ADDENDUM NO. 2
CONTRACT NO. CP8126-1 – GENERAL, MECHANICAL AND
ELECTRICAL CONSTRUCTION
 DATED: SEPTEMBER 27, 2010

SUFFOLK COUNTY DEPARTMENT OF PUBLIC WORKS
DIVISION OF SANITATION
HAUPPAUGE INDUSTRIAL PARK
S.C.S.D. NO. 18 – INDUSTRIAL SEWER DISTRICT EXPANSION
SUFF 0503

SUFF 0503
ADDENDUM #2 - ITEM LL
SHEET EEG2 - SKETCH # 21

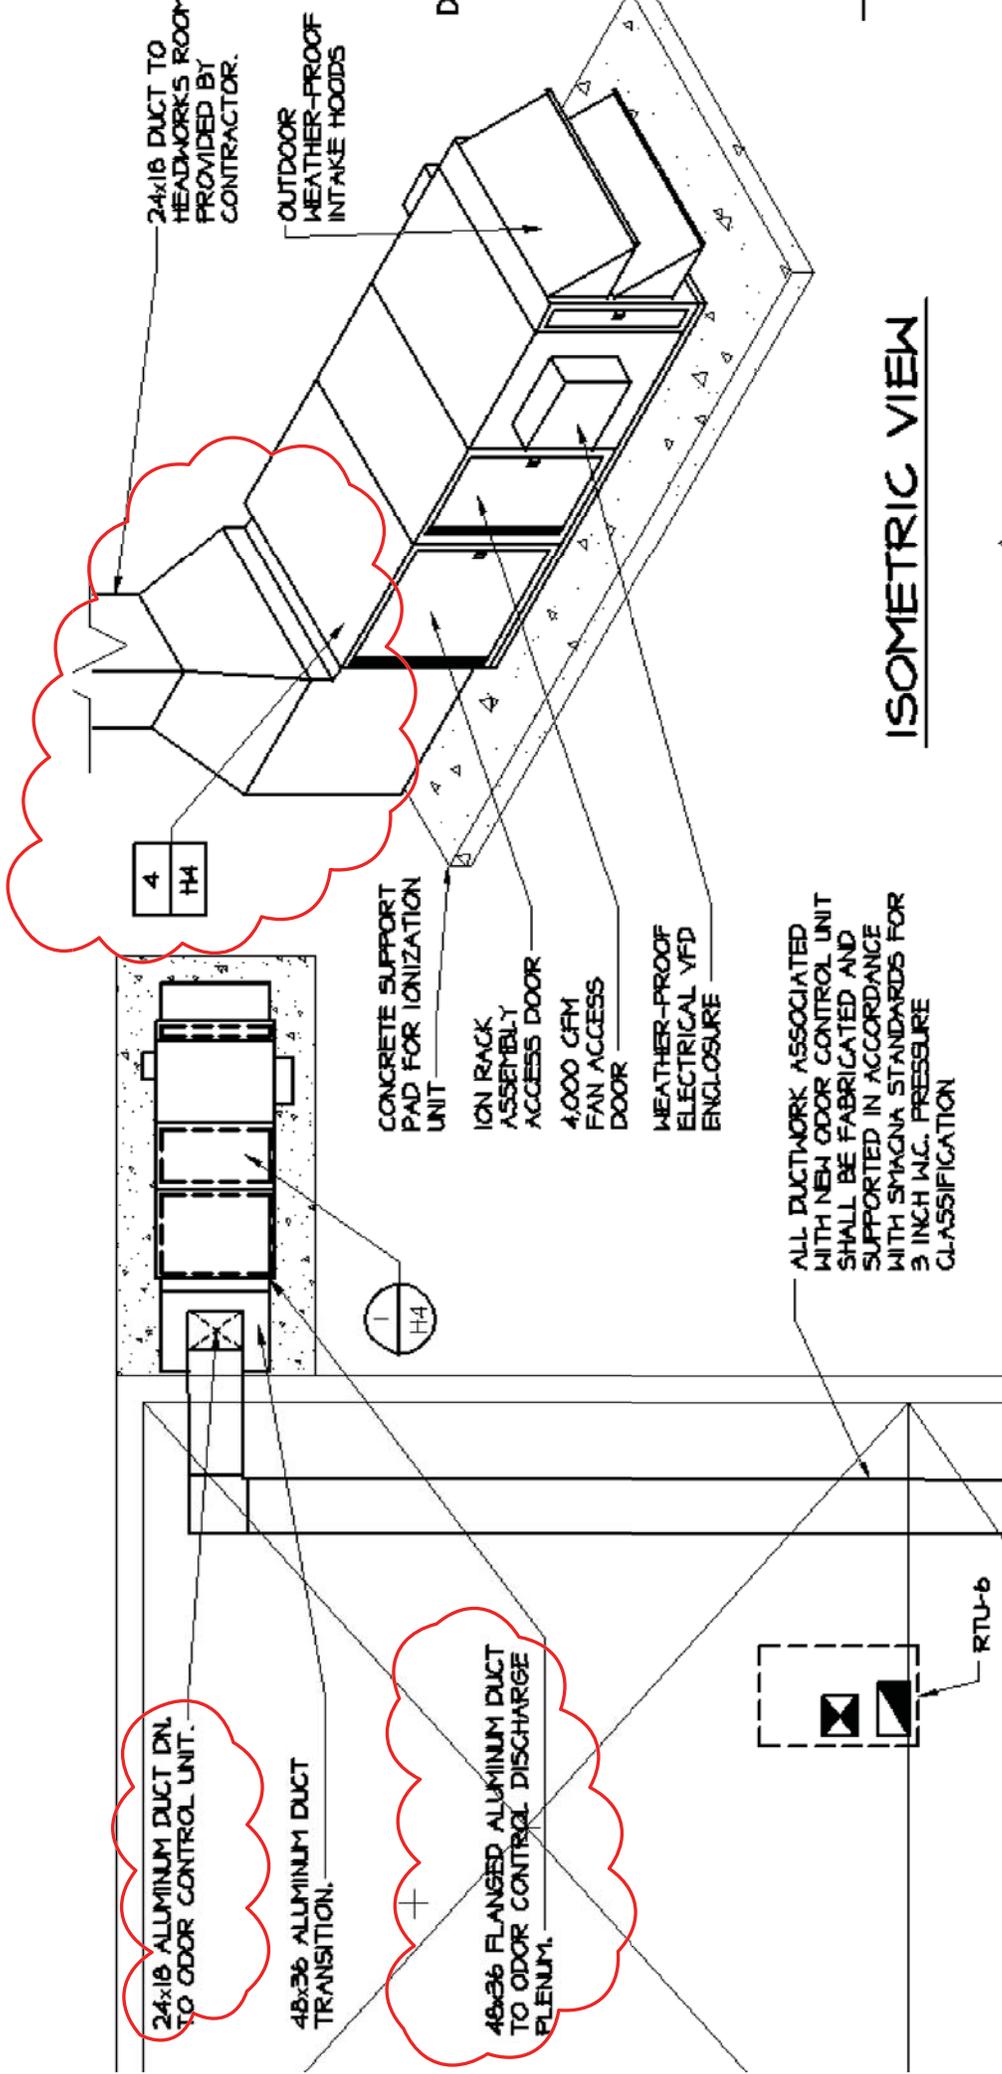
1. Detail #1: Change the wiring callout for the connection between the generator connection cabinet and section C of the generator switchboard from “3 SETS OF 4# 500 MCM + #3/0 AWG GND IN (3) 4” E.C.” to “4 SETS OF 4 - 350 MCM + #3/0 AWG GND IN (4) 3 1/2” E.C.”
2. Detail #1: Change the callout of wiring between the generator and automatic transfer switches in switchboard sections “D” and “G” from “2 SETS OF 30# 14 AWG IN 1 1/4” E.C. + CAT-5E IN (2) 1” E.C.” to “2 SETS OF 30# 14 AWG IN (2) 1 1/4” E.C. + (2) CAT-5E CABLES IN (2) 1” E.C.”.
3. Above revisions as shown on Sketch #21 included herein.

SUFF 0503
 ADDENDUM #2 - ITEM NN
 SHEET H4 - SKETCH # 22

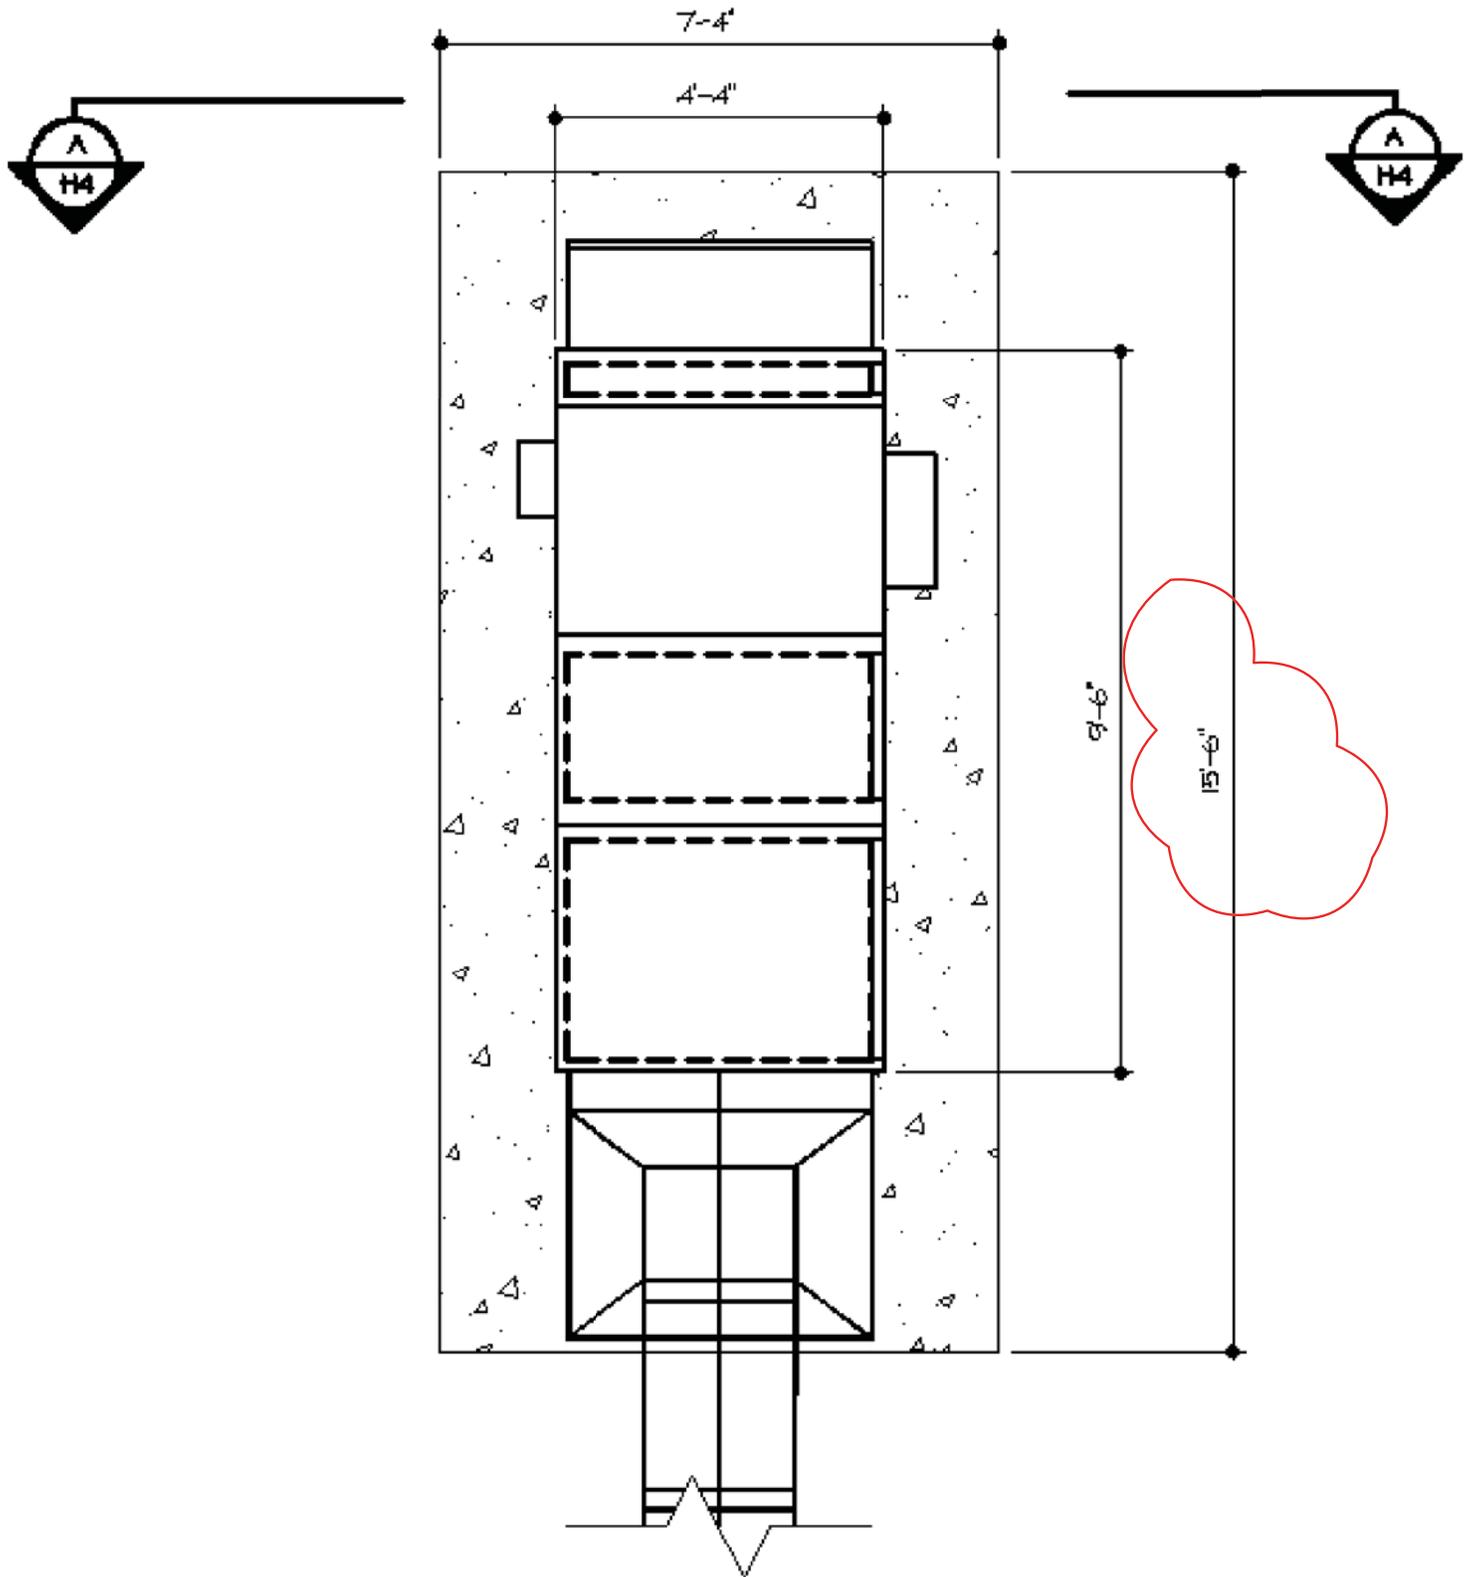
1. Detail #1 and Roof Plan:
 - a. Modify to depict side discharge and increase in size of concrete pad (see sketches #22 & #23 included herein).

SUFF 0503
ADDENDUM #2 - ITEM 001
SHEET H-C5 - SKETCH # 24

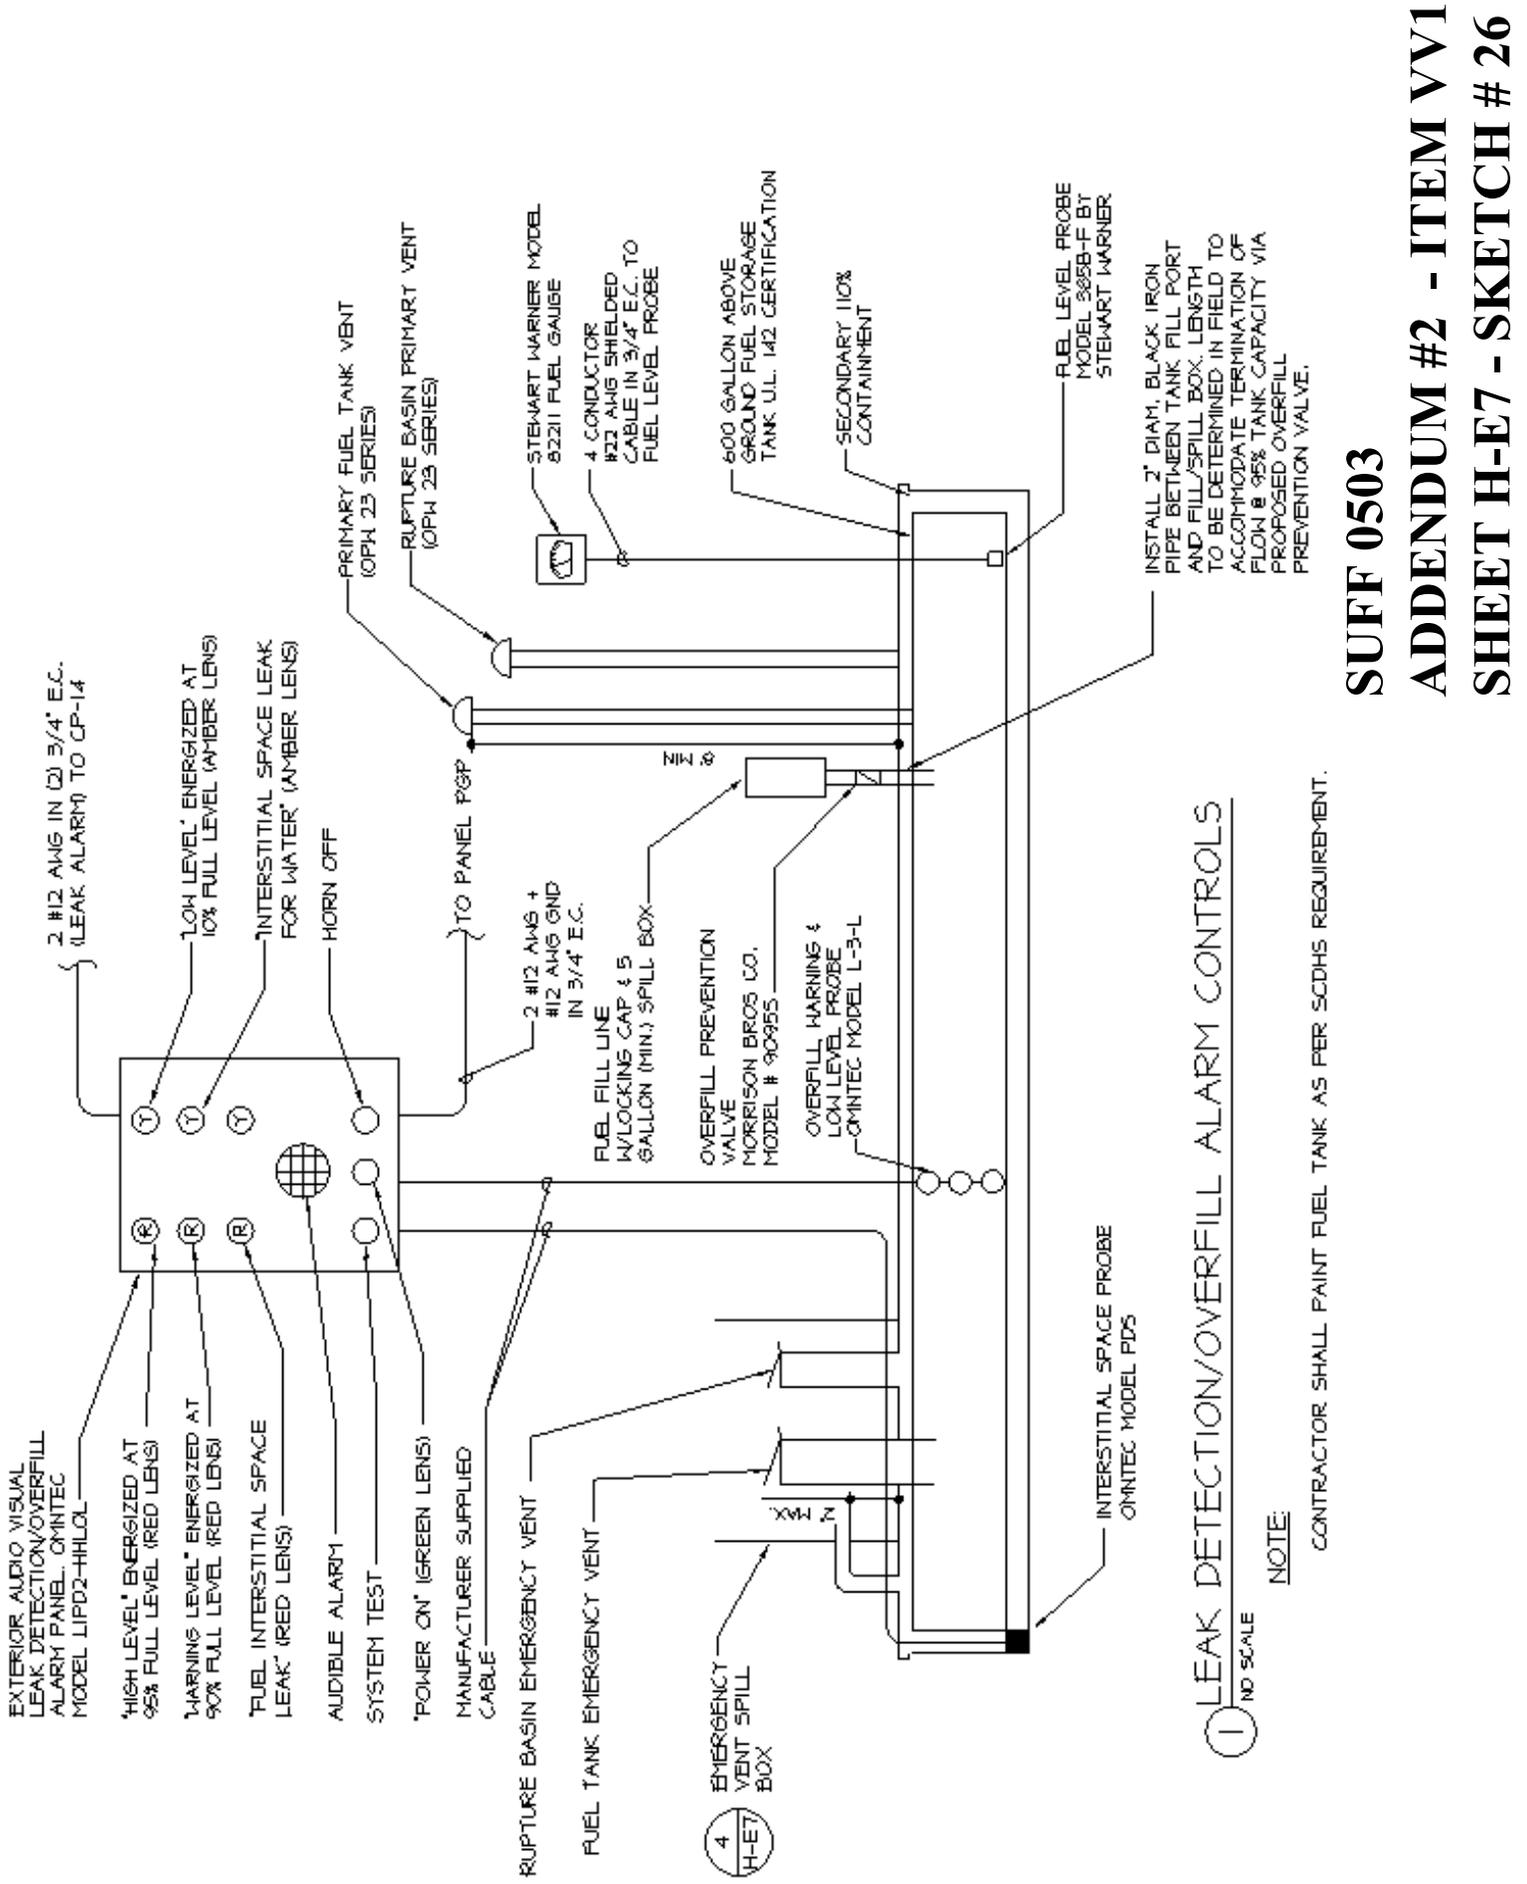
1. Add detail to show building sewer drop connection, chemical feed and concrete bench to be installed within new dog house manhole MH#23A. (see sketch #24 included herein)

SUFF 0503
ADDENDUM #2 - ITEM VV1
SHEET H-E7 - SKETCH # 26

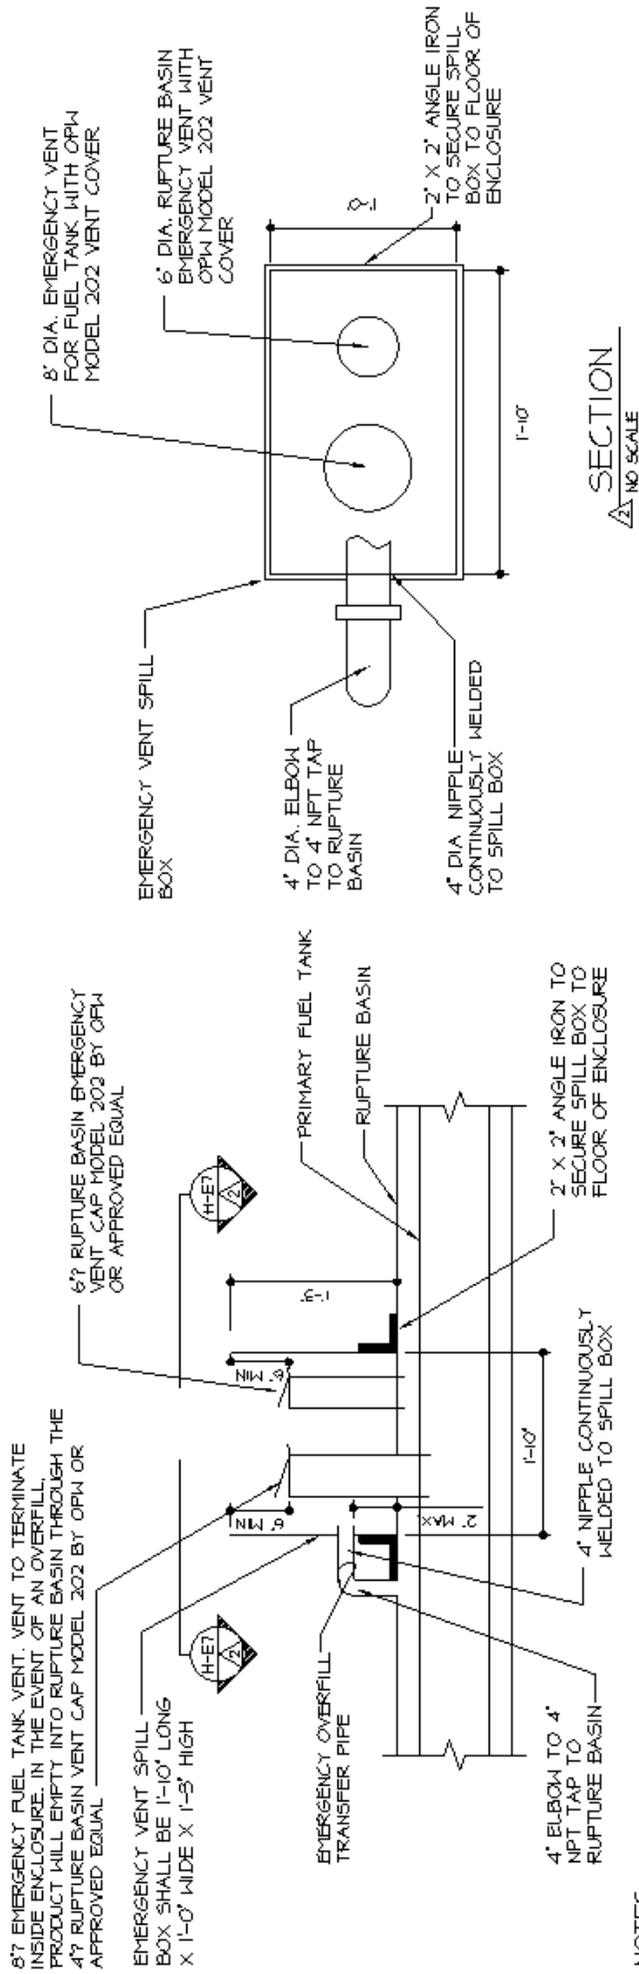
1. Detail #1: Update “LEAK DETECTION/OVERFILL ALARM CONTROLS” detail. (see sketch #26 included herein)
2. Detail #3: Modify circuit breaker callout from “15/1” to “20/1”.
3. Detail #4: Update “EMERGENCY VENT” detail with new detail entitled “EMERGENCY VENT SPILL BOX DETAIL”. Also add associated section view. (see sketch #27 included herein)
4. Detail #5:
 - a. Modify detail title to read “SECTION A-A”.
 - b. Insert callout for overall dimension of section to read “SEE GENERATOR PAD PLAN FOR DIMENSION”.
5. Detail #6: Update “FUEL SUPPLY SCHEMATIC” detail. (see sketch #28 included herein)
